SUBDIVISION COMMITTEE
METROPOLITAN AREA PLANNING COMMISSION

STAFF REPORT
(Preliminary Plat)

S/D 95-8 PAWNEE & WEST INDUSTRIAL PARK 2ND ADDITION

STAFF REPORT

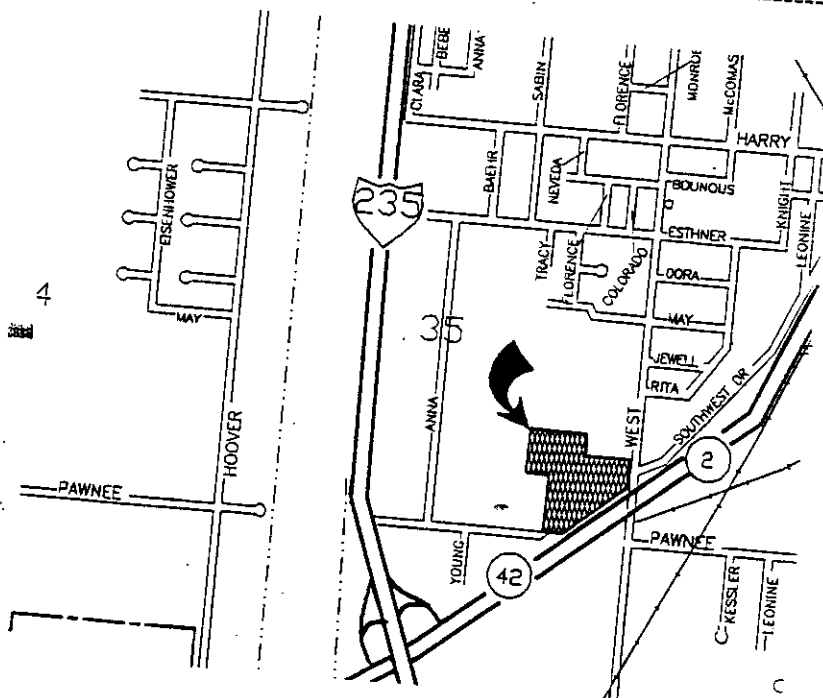
- A. City Engineering needs to indicate the status of existing guarantees or petitions for this site. That is, do these petitions need to be abandoned or amended and are there any charges for abandoned projects that need to be paid off.

- B. Based upon the significant changes in this plat's design, in particular the platting of West St. Ct., this site will likely require the submission of new guarantees. Specifically, guarantees for sanitary sewer, water, drainage, and paving (West St. Ct.) should be provided. Engineering needs to verify such requirements.

- C. Traffic Engineering also needs to indicate if the platting of West St. Ct. would require the need for any traffic improvements along West Street such as accel/decel lanes, left-turn lanes, and so forth.

- D. At the time that the original site was platted, requirements were made for this site to participate in the paving of a portion of Pawnee, located toward the plat's western end, which was still a gravel street. City Engineering needs to indicate if that paving requirement and existing guarantee is effected by this replat.

- F. It should be noted that the portion of Lot 4, of the original plat, not being included within this replat will not be an approved building site. At the least, a lot split may be required before any building permits can be obtained for that portion of a lot.

- G. In regard to the access from Lot 1 to West St., as can be noted, a joint access opening was originally platted between what was Lots 1 & 2. While this plat is continuing to show this opening, the applicant's agent has noted that because of utility facilities, they would like to shift this opening slightly southward or basically along Lot 1's frontage to West St. of this plat. A lot split for Lot 1 of the original plat is to be submitted, through which the 15-foot area of access at that lot's southeast corner could be eliminated. Traffic Engineering needs to indicate if the relocation of this access is acceptable.

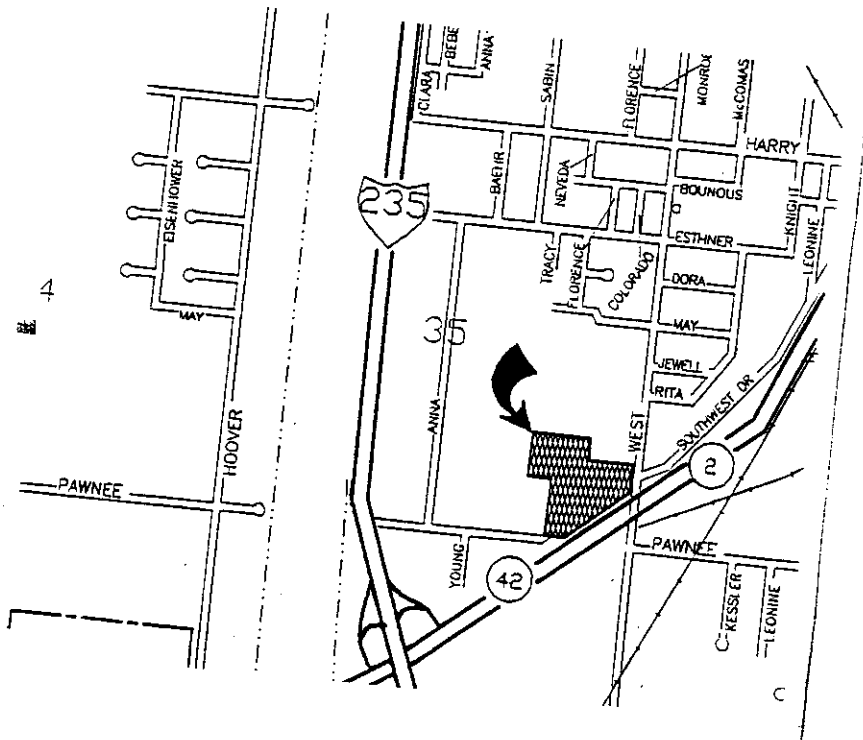
- A. Based upon the significant changes in this plat's design, in particular the platting of West St. Ct., this site will require the submission of new guarantees. Specifically, guarantees for sanitary sewer, water, drainage, and paving (West St. Ct.) should be provided.

- B. At the time of final plat review, Traffic Engineering needs to indicate if the platting of West St. Ct. would require the need for any traffic improvements along West Street such as accel/decel lanes, left-turn lanes, and so forth.

- F. The final plat tracing shall indicate the utility easements requested by K.G.& E. and Southwestern Bell which were indicated on a "marked" copy of the plat submitted to the applicant. Specifically ten (10) foot utility easements shall be shown along the common lot lines of; Lots 1 & 2, Lots 3 & 4, Lot 5 & 6, Lots 6 & 7, and Lots 9 & 10.

- G. Originally, the applicant was requesting that Lot 1 be allowed an opening to West Street in order to actually allow the property to the north to use such opening. A recent lot split involving that property no longer indicates the need for such access. The final plat tracing shall therefore indicate complete access control to West Street from this lot. Both the face of the plat and the plattor's text shall indicate this access control.

- H. In regard to access control, the plattor's text shall be amended to indicate the dedication is to the City of Wichita and since no openings to West are now needing approval, reference to the Appropriate (City) Engineer can be deleted.
